SUBJECT: Forwards addl info re 10-yr inservice insp program, per NRC
 860610 request for addl info. Status of relief requests re
 preservice insp also requested.

Subject: NUCLEAR PLANT NO. 2
INSERVICE INSPECTIONS AND INSERVICE
TESTING PROGRAMS AND RESPONSE TO
REQUEST FOR INFORMATION

RESPONSE TO NRC's
REQUEST FOR ADDITIONAL INFORMATION
FOR WASHINGTON PUBLIC POWER SUPPLY SYSTEM
WPPSS NUCLEAR PLANT NO. 2
DOCKET NUMBER 50-397

WNP-02
INTERVAL: 01
DRAWING NO. RHR-208

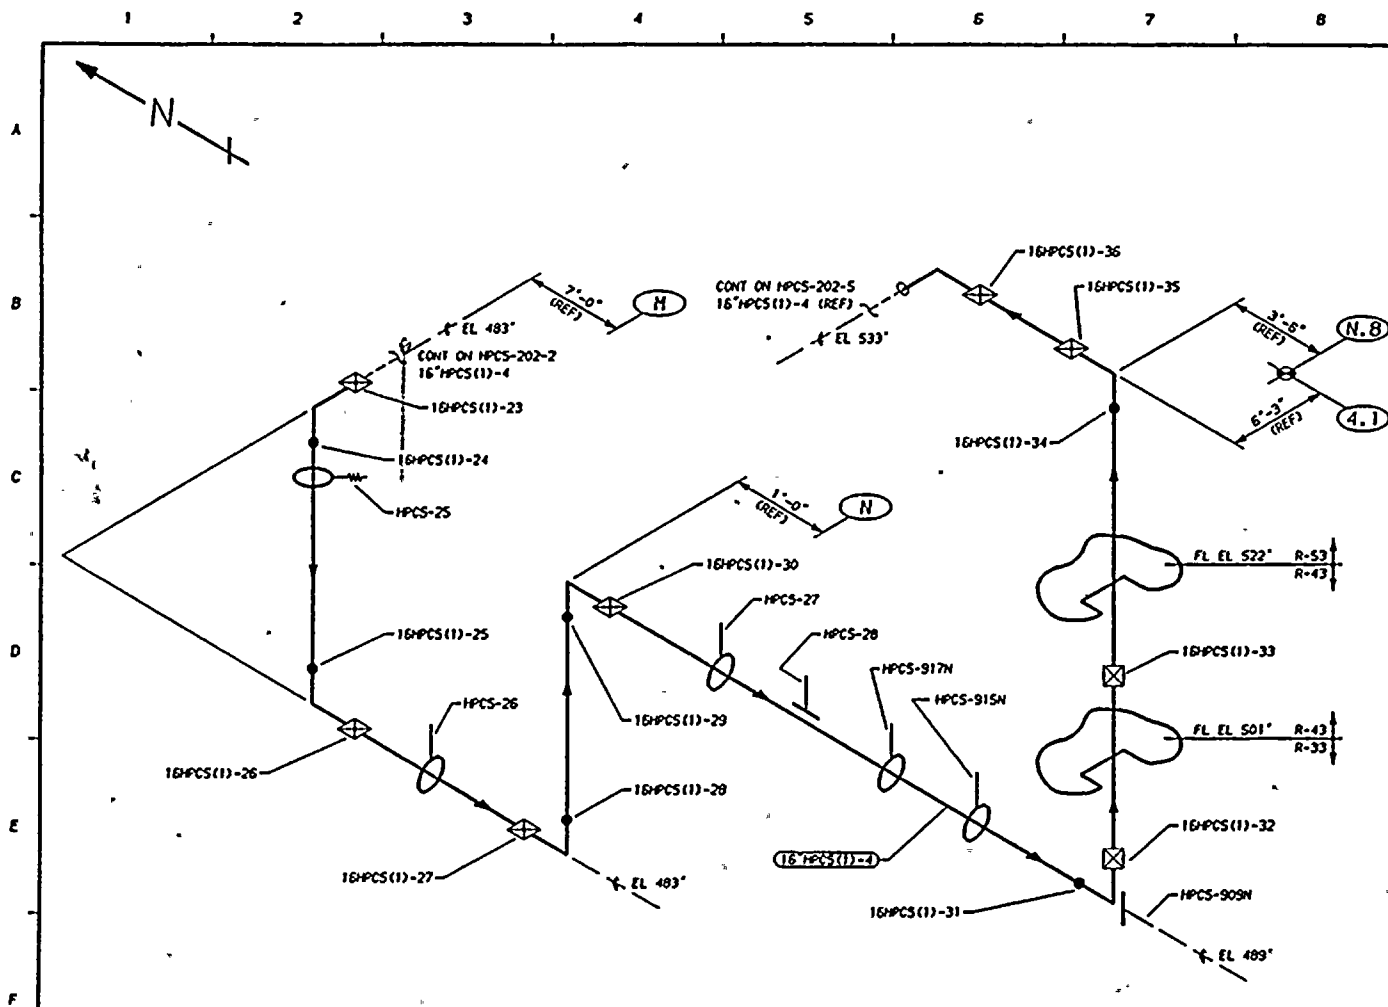
- A. In Section 14.0, "Weld and Component Identification Diagrams," of the ISI Program Plan, the Program Plan and Schedule Tables list the following welds as being inspected to Table IWC-2500-1, Examination Category C-F-2, Item C5.51 of the Code with only surface examination being required:

To satisfy the inspection requirements of Item C5.51, these welds require both surface and volumetric examinations. Clarification of this issue is needed.

The Supply System revised the WNP-2 ISI Program Plan and has included in it a surface and volumetric examination requirement for each of the above listed welds. Attached markups reflect this change.

DWG NO: HPCS-202-4

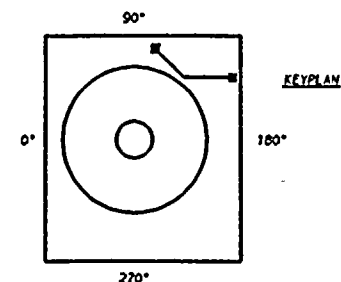
- B. Isometric Drawing No. HPCS-202-4 is missing from the ISI Program Plan. Provide the staff with a copy of this drawing.

Enclosed is a copy of ISI weld and identification diagram HPCS-202-4, Rev. 2. This drawing was being revised and inadvertently omitted.
